## ORIGINATION FORM

### Proposed Revisions to a Standard Plans Index (Please provide all information — Incomplete forms will be returned)

Index Number: 700-106  
Sheet Number (s): 1 & 2  
Index Title: Rural Narrow Bridge Treatment

INDEX <b>700-106</b>	SHEET <b>1 of 2</b>
-------------------------	------------------------

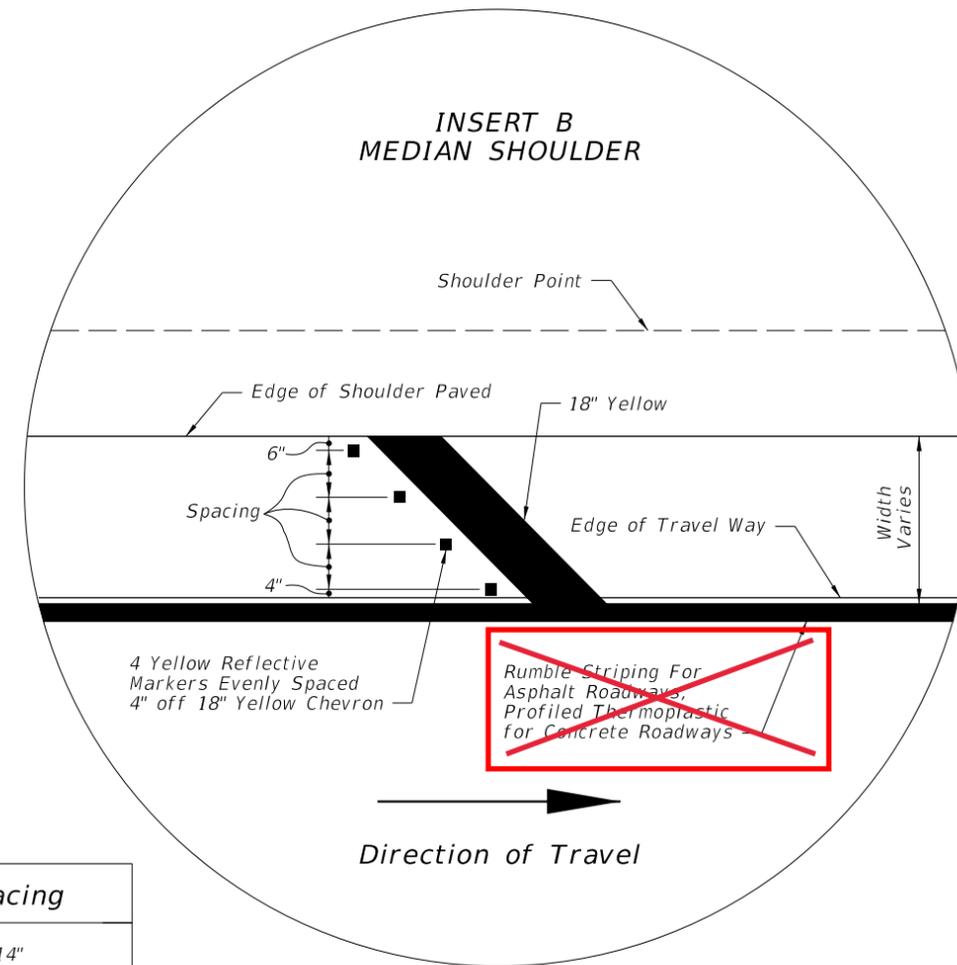
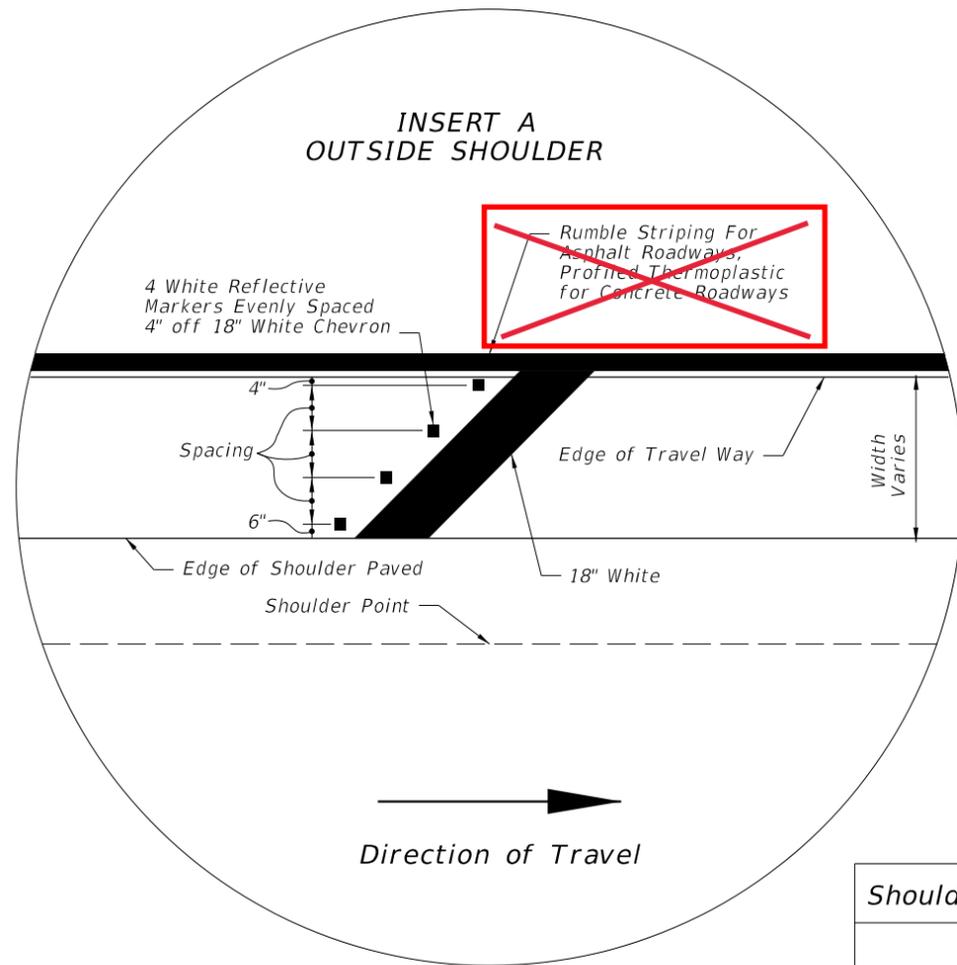
Sheet 1: Updated the guardrail layouts illustrated to include Parallel Approach Terminals.

The Department no longer uses Flared Approach Terminals for new installations of guardrail; therefore, for consistency with Index 536-001 details, the layouts shown on Sheet 1 are updated to show Parallel Approach Terminals. Sheet 2 references to Rumble Striping were removed for consistency with current policy (RDB18-03).

Updated Guardrail layout to include Parallel End Treatments.

Used Index 536-002, Sheet 2, Detail S (shown left).

INDEX  
700-106

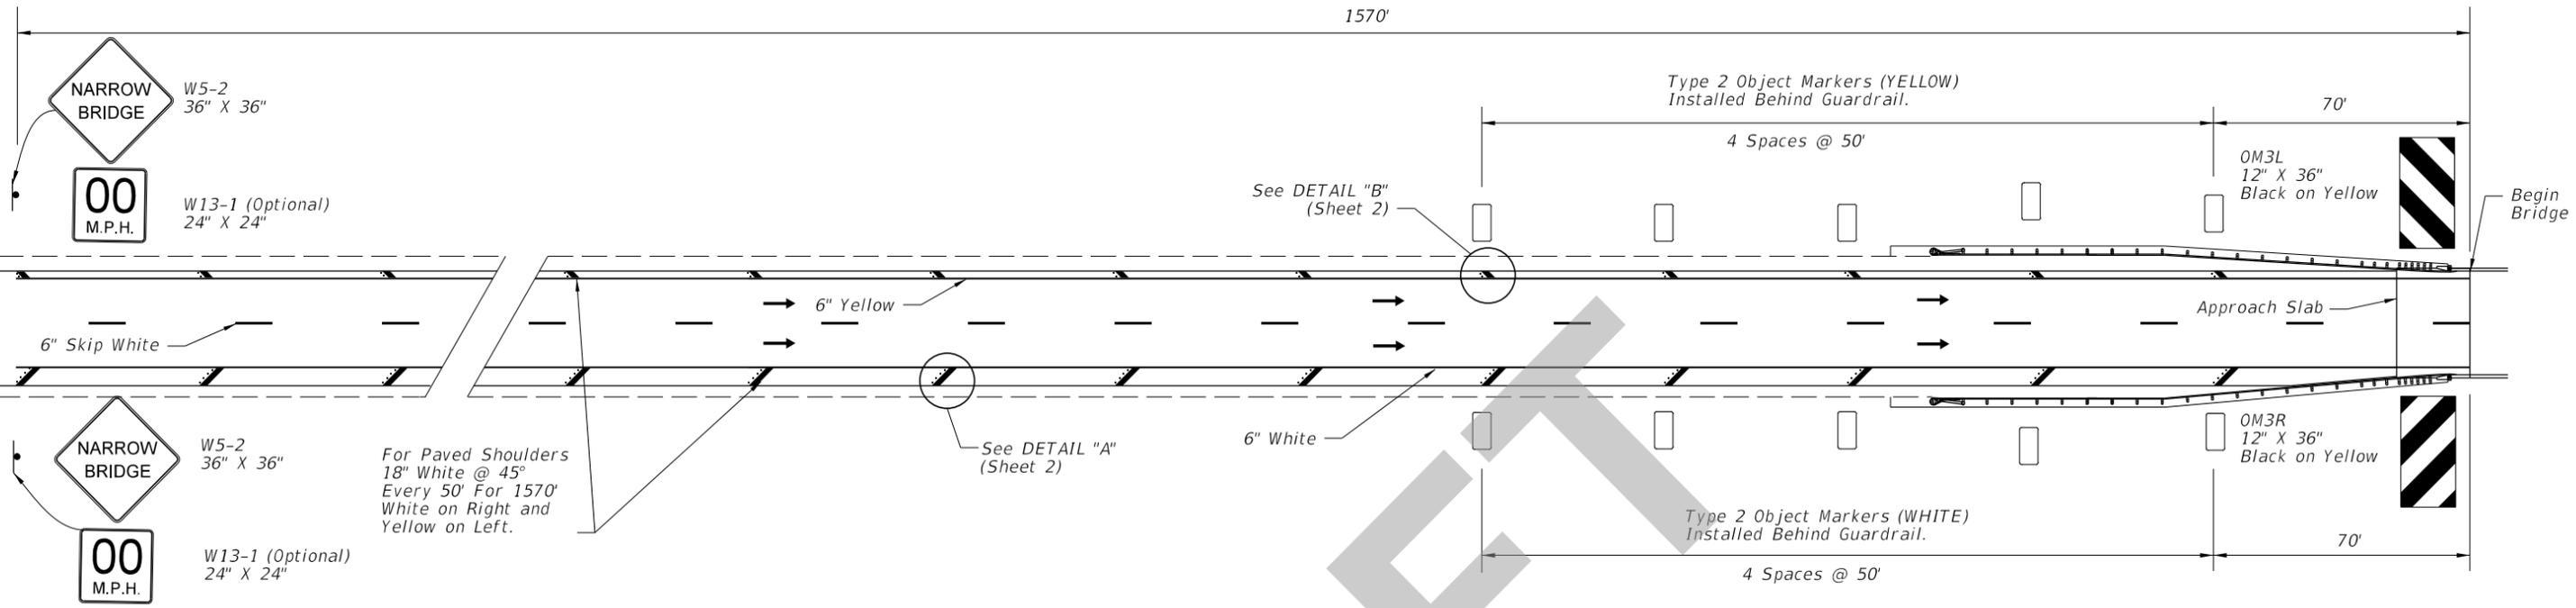
Sheet 2: Removed call-out references to the Rumble Striping and Profiled Thermoplastic in the 'INSERT A' and 'INSERT B' details. Added new Note #5, to refer to the Plans for the installation Audible and Vibratory treatments.

Added Note 5

5. Install Audible and Vibratory treatments (e.g., ground-in rumble strips or profiled thermoplastic) in accordance with the Plans.
